<u>City of Chattanooga</u> <u>Rainwater Management Guide (RMG) – Addendum # 1</u> <u>Effective Date – 11/29/2017</u>

This Addendum shall be used in conjunction with the December 1, 2014 edition of the City of Chattanooga's *Rainwater Management Guide* (RMG) to regulate stormwater control measure design, operation, and maintenance. The latest edition of the *Rainwater Management Guide* can be downloaded at the following web address: <u>http://chattanooga.gov/public-works/water-quality-program/resource-rain</u>. The addenda noted below are the City of Chattanooga's additions, clarifications, and exceptions based on the revised City Stormwater Ordinance, approved by Chattanooga City Council on November 21 and 28, 2017, and became effective upon signature by the Mayor and City Council Chairperson, as well as knowledge gained over the past three years of Stormwater Control Measures implementation.

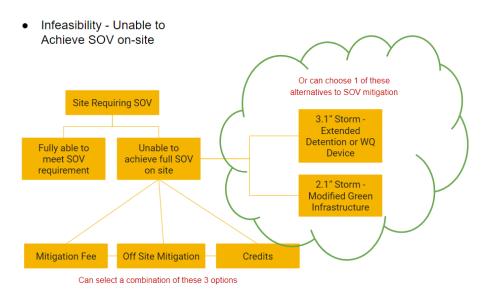
On projects where conventional, onsite SCM's are infeasible for SOV, offsite mitigation and/or use of coupons are still allowed. However, in-lieu of offsite mitigation or using coupons, one or a combination of the following methods may be used to remove a minimum of 80% TSS from the stormwater when "infeasibility criteria" has been met:

- 1. modified green infrastructure using 2.1" storm, and/or
- 2. extended detention pond using 3.1" storm, and/or
- proprietary, man-made devices meeting NJCAT verification (<u>www.njcat.org</u>) and using 3.1" storm.

The following diagram below illustrates this process:
